**ADMINISTRATIVE NON-STANDARD LOCATION**

**Administrative Order NSL – 9143**

**Chevron U.S.A., Inc. [OGRID 4323]  
ZN 34 27 Federal State Com Well No. 607H  
API No. 30-025-55027**

**RE: Application of Chevron U.S.A. Inc. for administrative approval of unorthodox well location for its ZN 34 27 Fed State Com 607H well located in a 480-acre, more or less, horizontal spacing unit comprised of the W/2 of Section 27 and the NW/4 of Section 34, Township 23 South, Range 34 East, Lea County, New Mexico**

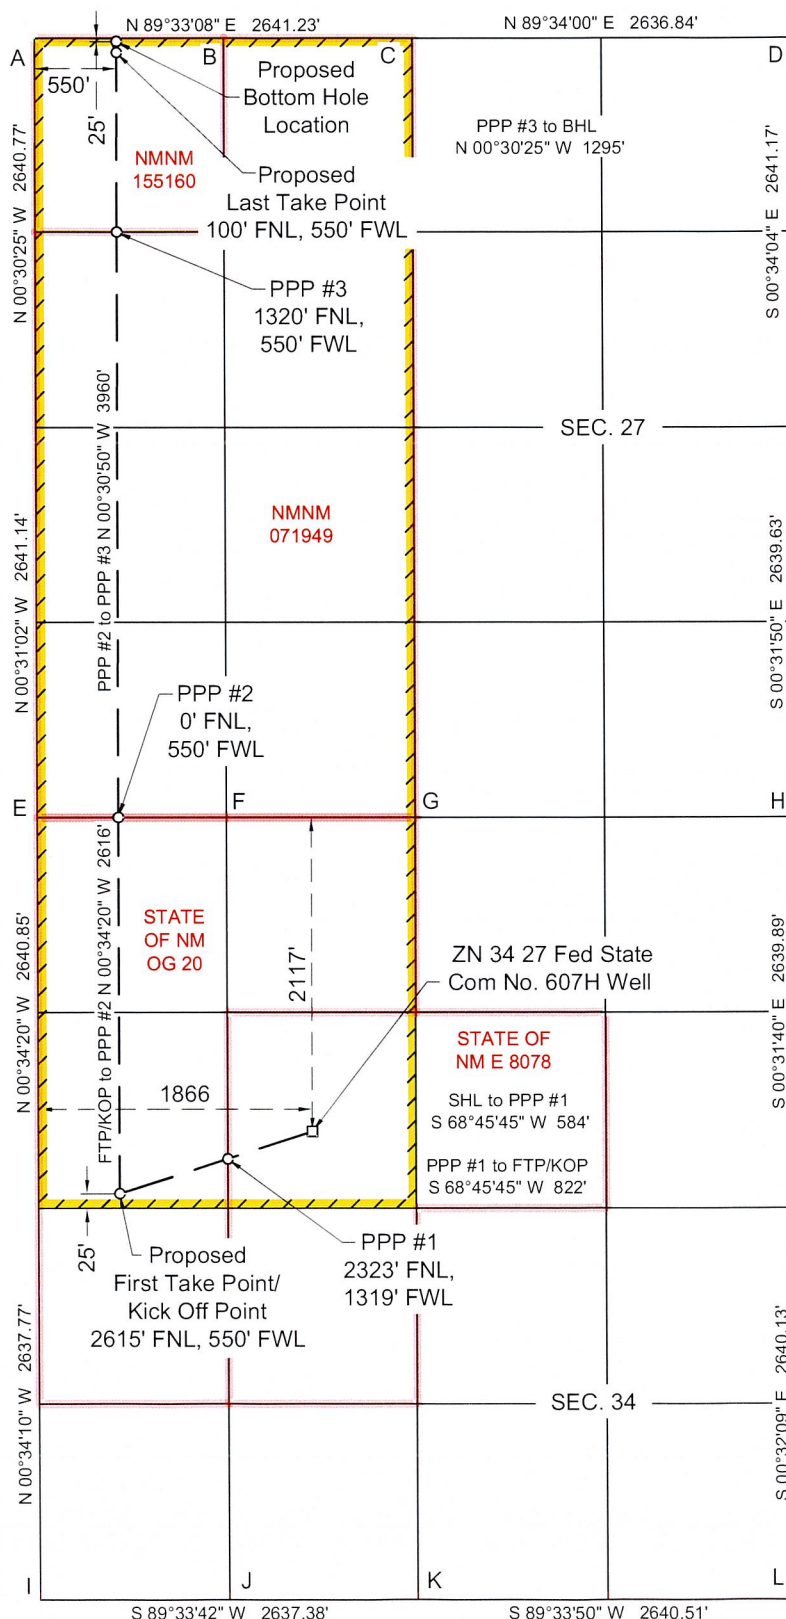
This well's completed interval is as close as 25 feet to the southern edge of the horizontal spacing unit. Encroachment will impact the following tracts.

The Antelope Ridge; Wolfcamp Pool is an oil pool subject to the state-wide rules, which establish a 100' setback requirement for the first and last take points of a well to the outer boundary of the spacing unit. The Well's **first take point** will be closer than 100' from the outer boundary of the spacing unit, which requires an NSL approval. As shown on Exhibit A, this is a horizontal well that will be drilled as follows:

As discussed above, the Well's **first take point** will be closer than 100' from the outer boundary of the spacing unit. *See* Exhibit A (C-102). The unorthodox location will encroach towards the N/2SW/4 of Section 34, Township 23 South, Range 34 East.

Per 19.15.15.13 (B) NMAC, **Division approves this unorthodox location.**

Chevron has included as Exhibit B a letter explaining why this application is needed. Chevron also provides a map of the area, attached as Exhibit C, which shows the tracts upon which the unorthodox location will encroach.

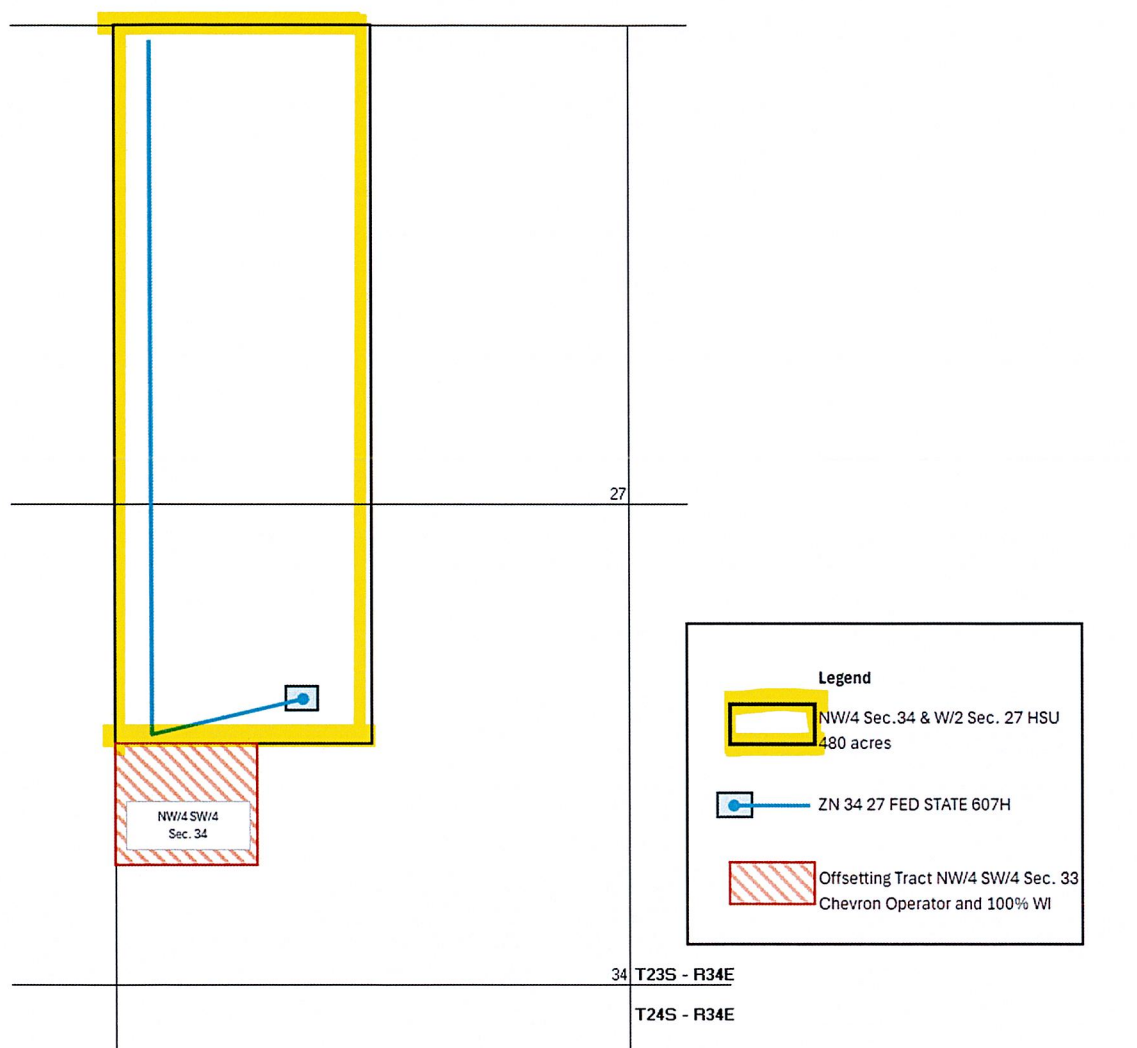
**Chevron is the operator and owns 100% of the working interest in N/2SW/4 of Section 34, Township 23 South, Range 34 East.** Pursuant to Rule 19.15.4.12(A)(2) and Rule 19.15.2.7(A)(3), Chevron is thus only providing notice to the Bureau of Land Management. Proof of mailing along with a copy of the letter sent to the Bureau of Land Management are included in Exhibit D. Chevron's landman has provided a letter confirming the ownership in the N/2SW/4 of Section 34, Township 23 South, Range 34 East, which is included as Exhibit E.
